OFFICIAL STAR CLASS MEASUREMENT CERTIFICATE**Sec. C.****—INSTRUCTION TO CERTIFIED MEASURERS—**

YACHT NO. 3125

1. YACHT'S NUMBER? 3125
2. Was this number cut or burned into keelson as required above? CUT
3. Yacht's name "SHANNON" 4. Year built 1951
5. By whom built? OLD GREENWICH BOAT CO.
6. Owner's Name E.W. ETCHELLS
7. Address ROCKY POINT RD. OLD GREENWICH, CONN
8. Fleet C. L. I. S. 9. Remarks Phone 7-0277

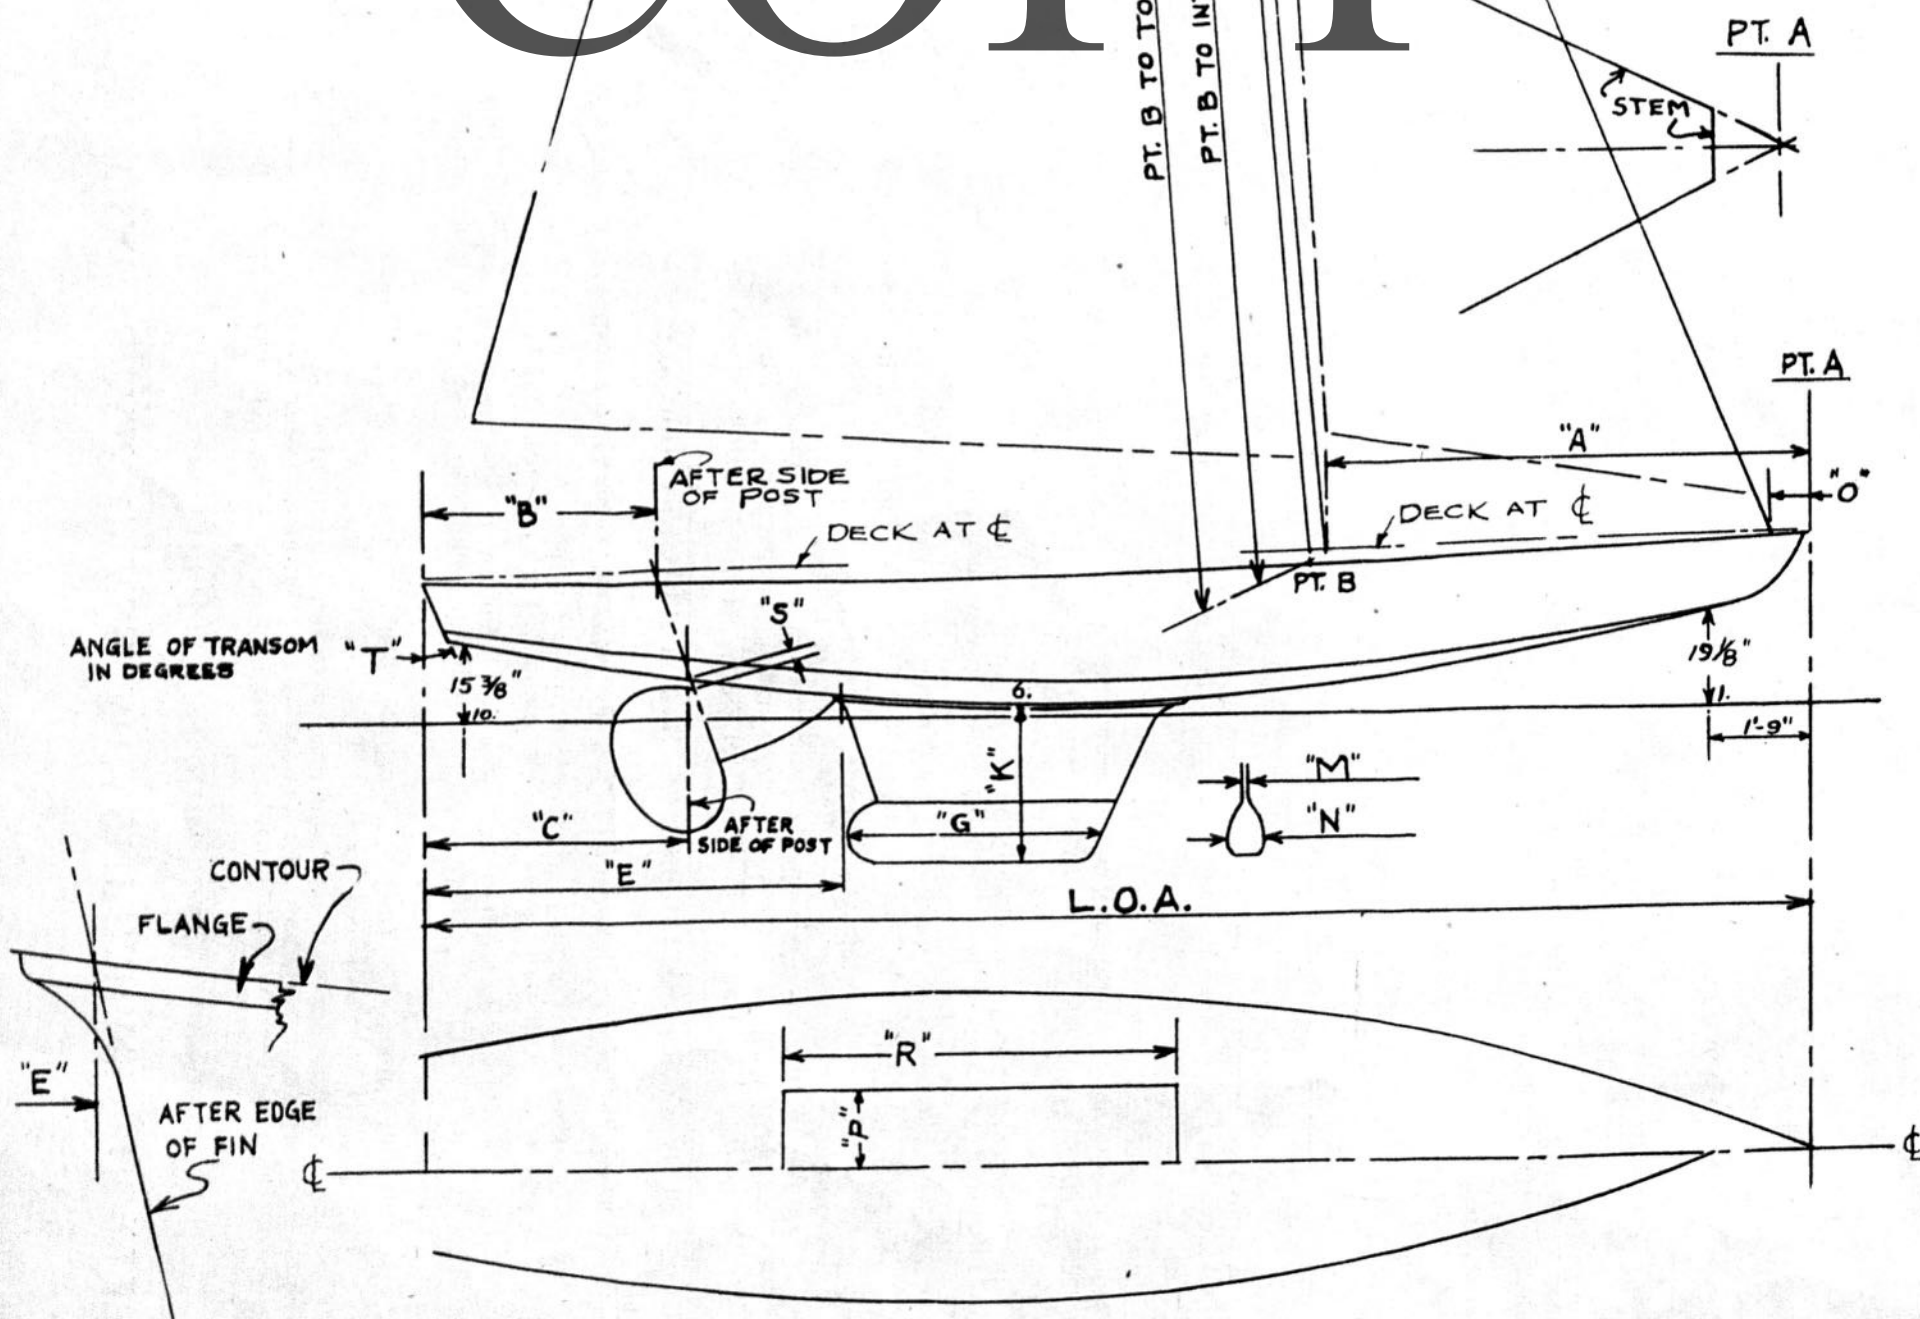
Am returning 1 copy of
3125 - E is 7/16" under
minimum. Fairing over rudder
not as per plan.

E + chells called me. I told
him about both and said when
you certify to me that E is OK
and the fairing removed I will
issue certificate.

Re: #3125 - the rules
do not cover the following
but I believe I should
mention that Etchells
has put a fairing piece
aft of the mainmast, like

*Beery showed
me 8/16/51 after recheck
of boat which gave
new dimension as 83 3/4"
outside + 84 3/16" moulded
inside planking.*

Beery showed
me Etchells has
brooded this
off. 8/16/51
Small
